COUNCIL ASSESSMENT REPORT

Panel Reference	2017SNH074
DA Number	359/17
LGA	North Sydney
Proposed Development	Alterations and additions to hospital including a 2 storey extension to the existing ward block, with two levels of clinical accommodation, an additional building of 2 levels, a landscaped courtyard between the buildings and two lower levels of car parking
Street Address	35 Rocklands Road Wollstonecraft
Applicant/Owner	Keith Lapthorne, St Vincent's Healthcare Ltd
Date of DA lodgement	6 October 2017
Number of Submissions	19 to original plans and 28 to amended plans received 16 May 2018
Recommendation	Deferred Commencement Approval
Regional Development Criteria (Schedule 7 of the SEPP (State and Regional Development) 2011)	CIV > \$5M - Private infrastructure and community facilities
List of all relevant s4.15(1)(a) matters	<p>North Sydney LEP 2013</p> <ul style="list-style-type: none"> • Zoning – SP2 Infrastructure - Health Care Facility • Item of Heritage – No • In Vicinity of Item of Heritage – Yes • Conservation Area – No <p>SEPP 55 - Contaminated Lands SREP (Sydney Harbour Catchment) 2005</p> <ul style="list-style-type: none"> • North Sydney DCP 2013

List all documents su

Photo showing unit 160 balcony and terrace of unit 162 (unit 161 behind tree)

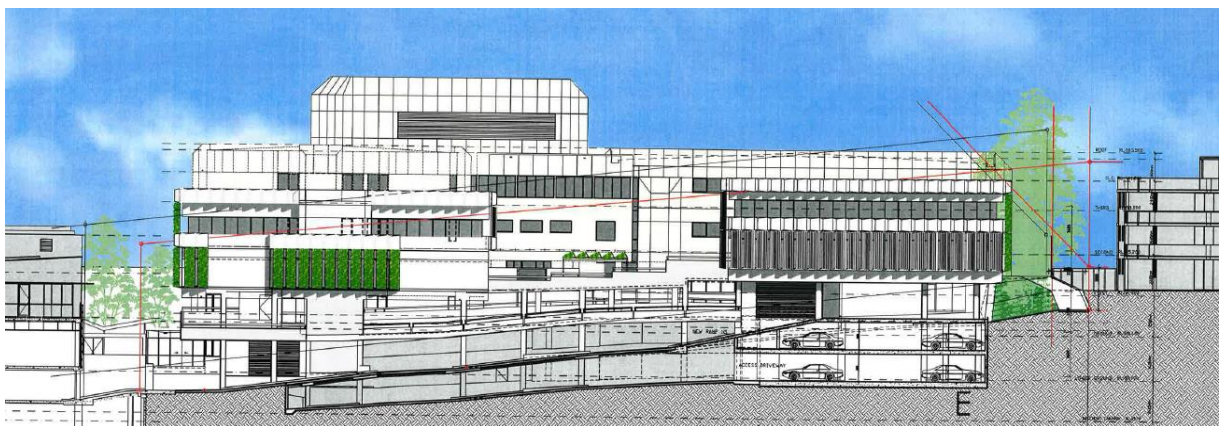
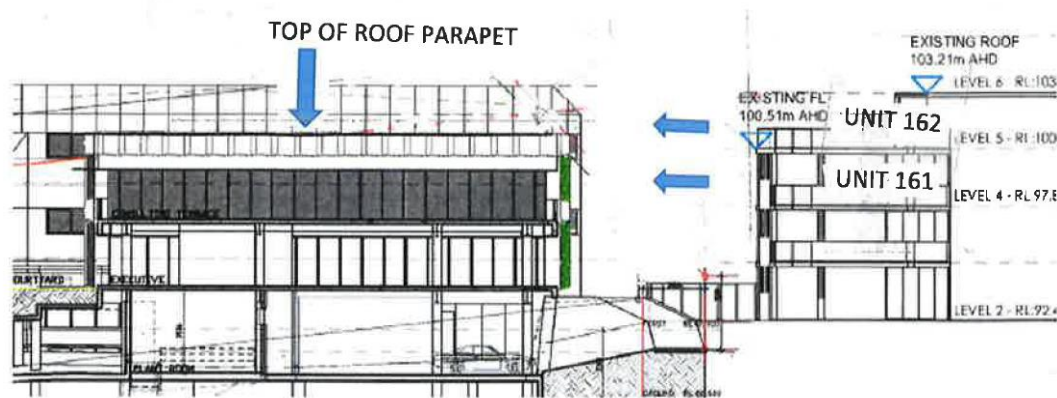
Comment: The view from unit 162 is likely to be affected by the proposed buildings by taking out the lower part of the water view and tree canopies. This would be a moderate view loss.

Comment: The impact on view loss for unit 162 is caused by the Palliative Care building more than the Executive building. It is noted that the parapet of the building is 800mm higher than the roof height and it would be possible to reduce the height of the parapet by 500mm which would reduce the amount of view loss and probably retain the majority of the water view. The parapets on both building should be lowered.

It is not so easy with the units below. The Executive building that is blocking the view complies with the 12m height control. This building also blocks views across the site from other apartments behind the tennis court on a similar level to 160 and 161.

To lessen the impact of the scale of the building and amenity impacts on the neighbours at 41 Rocklands Road, the separation distance could be increased but this would not retain the view from the lower level units.

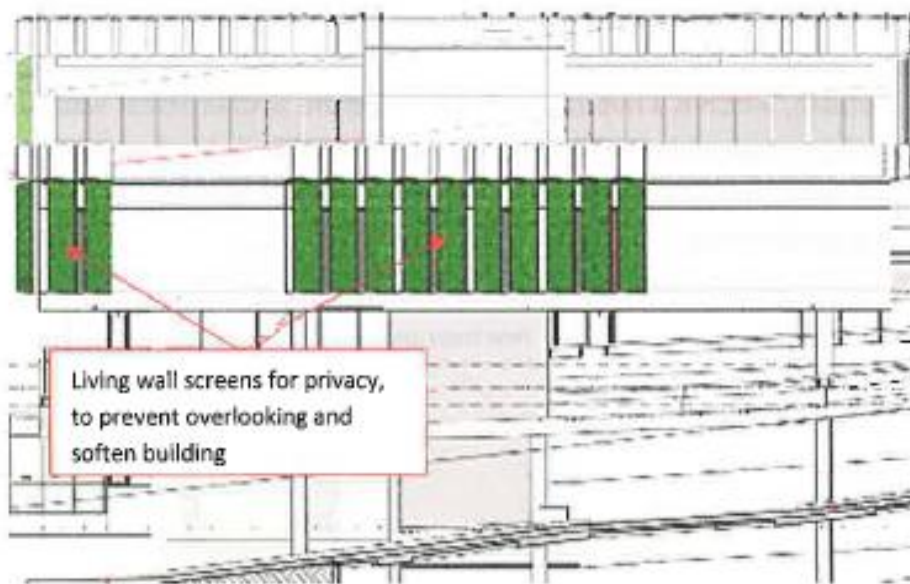
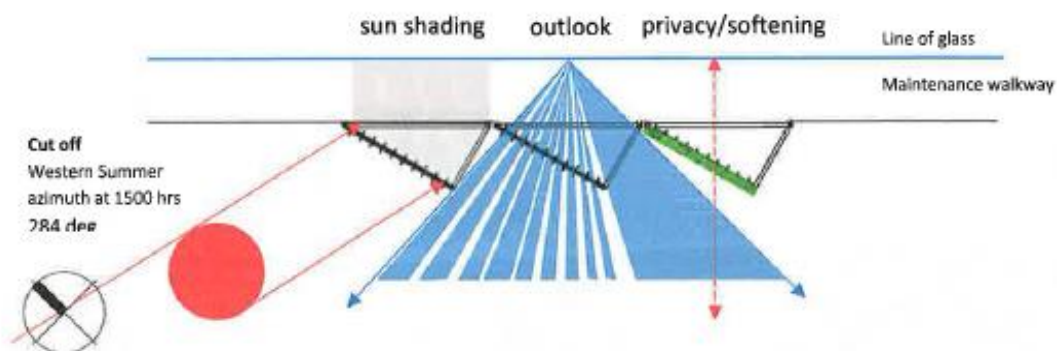
The proposed screens do not provide sufficient privacy for the adjoining neighbours. There should be additional screening incorporated (possibly more overlapping of the panels or solid wall instead of glass wall) to ensure that there is no overlooking where windows are directly opposite the apartments. The terrace balustrades also require detail of screening at least to a height of 1.6m above floor level. The proposed screens also do not address the problem of light spillage from the buildings where they face the neighbours. Details of window treatment/blinds that can be guaranteed to be closed at night need to be provided to resolve this concern.

- ii. The northern (Executive) building being setback an additional 2m setback from the northern boundary;
- iii. additional privacy screening being provided to all windows opposite apartment buildings and along the terrace edges;
- iv. provision of screening (planting and/or architectural panels) on the eastern edge of the carpark below the courtyard;
- v. details of window treatment/blinds that can control light spillage from both buildings where they are opposite apartment buildings;

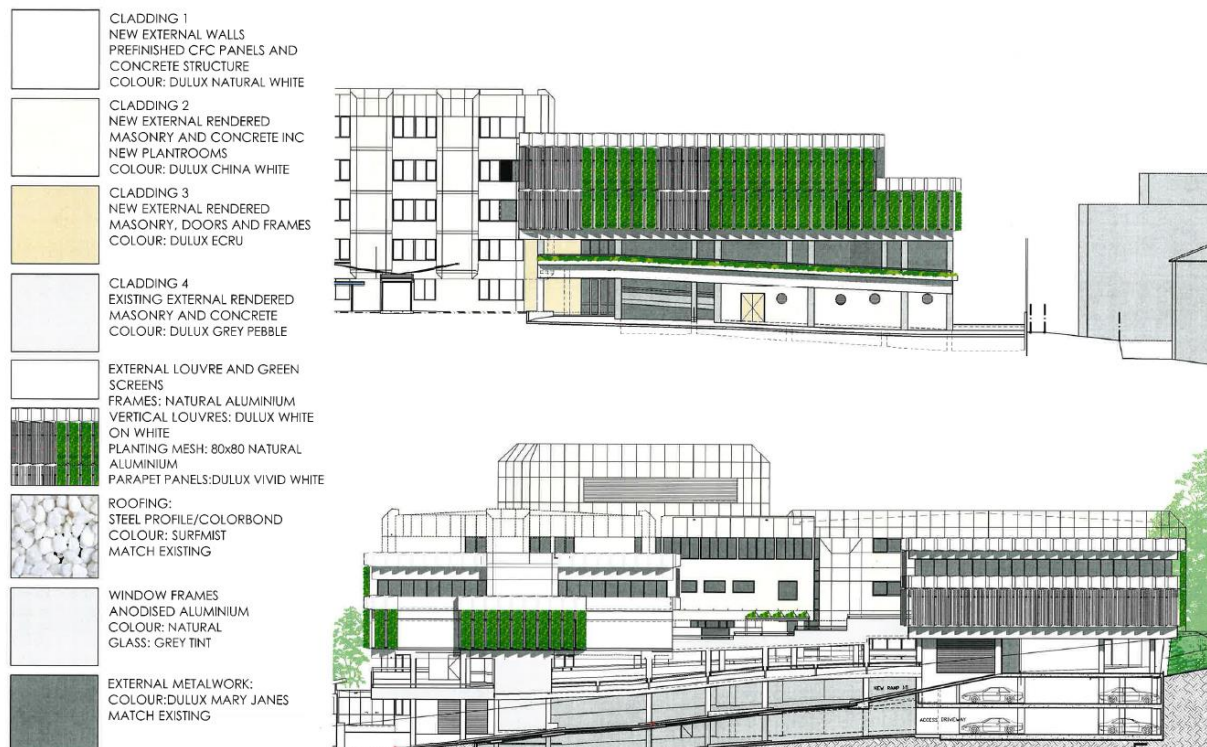
The Executive building complies with the setbacks from the northern boundary but breaches the height plane from the eastern boundary by up to 1m (due to the slope of the site along the vehicle ramp) for a small section at the southern end.

The Palliative Care building generally complies other than a 500mm breach at the terrace balustrade for a small section at the southern end.

Although the Executive building numerically complies with the setback. The impact of the building on the amenity of nearby residents and the landscape buffer warrants additional setbacks. It can be a decision for the applicant to decide whether to move
